SAN ANTONIO WATER SYSTEM
DSP Southeast Tank and Pump Station Project
SAWS Job Nos. 13-6102 (DSP) & 13-6005
Solicitation No. CO-00006

ADDENDUM NO. 10

September 8, 2015

Sheet P-10

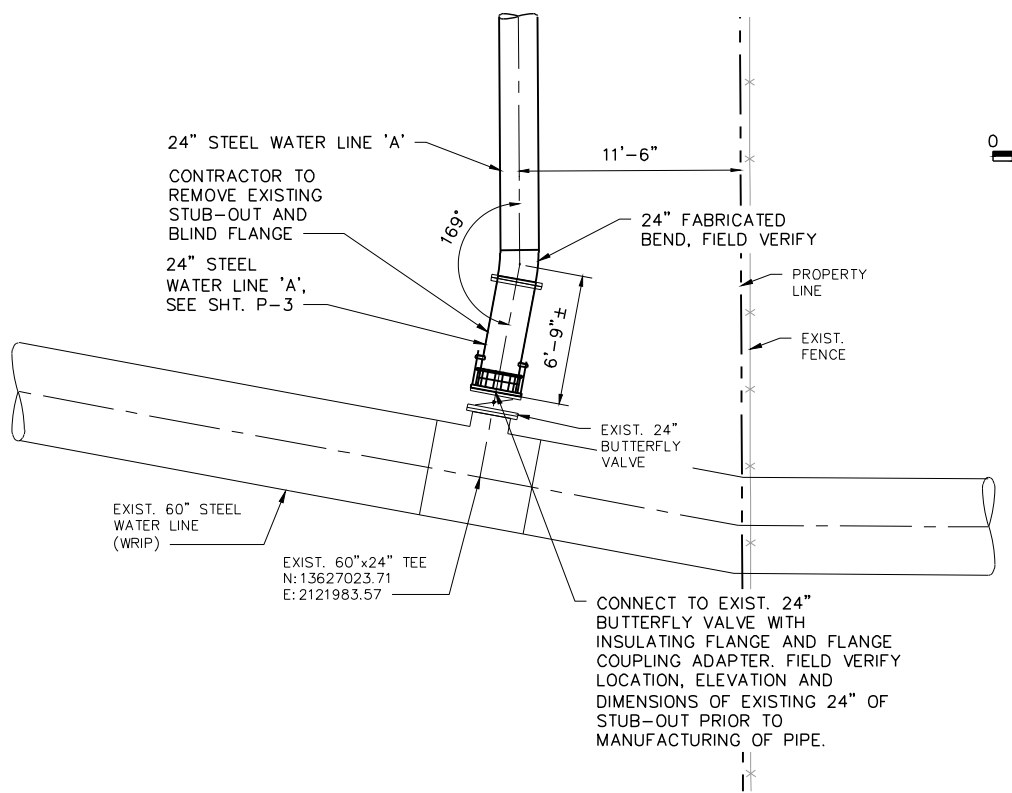
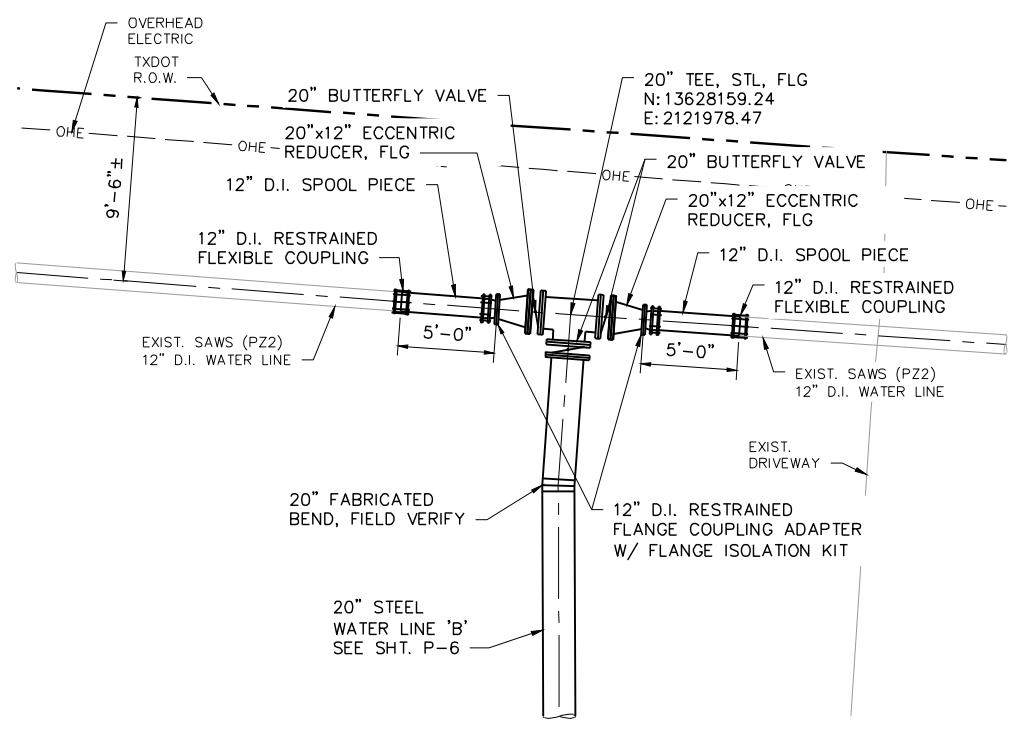
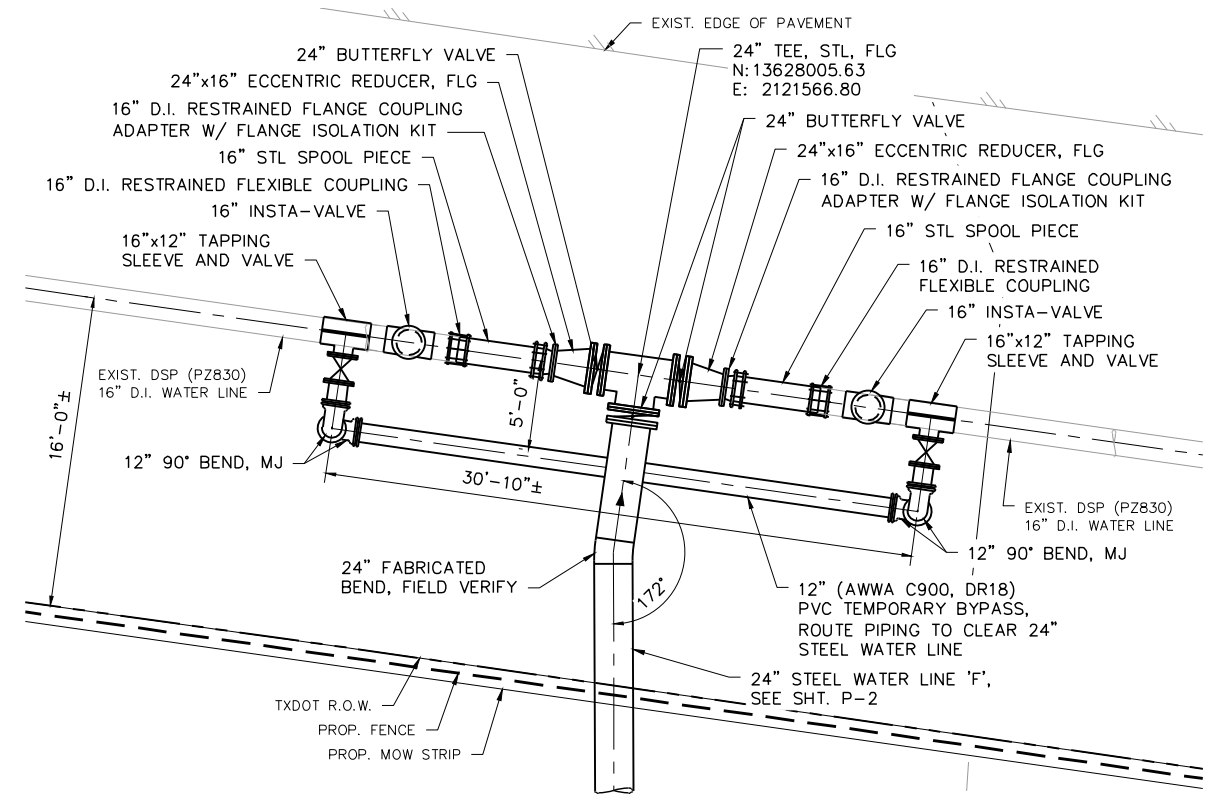
3. **Question:** Can the steel pipe fabricator use AWWA CL E flanges which are rated for 275# PSI working pressure, but are drilled 150# for all flanged connections? See sheet P-10 detail 2, the steel (CL 150 lb drill) flange reducer will have a CL E x CL F (250 lb drill) flange in order to bolt to the 250 lb drilled butterfly valve.
 3. **Answer:** Sheet P-10 does not list flange class of fittings. All flanges to be Class 250 per the Contract Documents. See Addendum No. 10, Part 3, Item No. 1.

4. **Question:** What flange drilling is the existing BFV on sheet P-10 detail 1?

4. **Answer:** Contractor to field verify flange drillings of existing water lines. See Addendum No. 10, Part 3, Item No. 1.
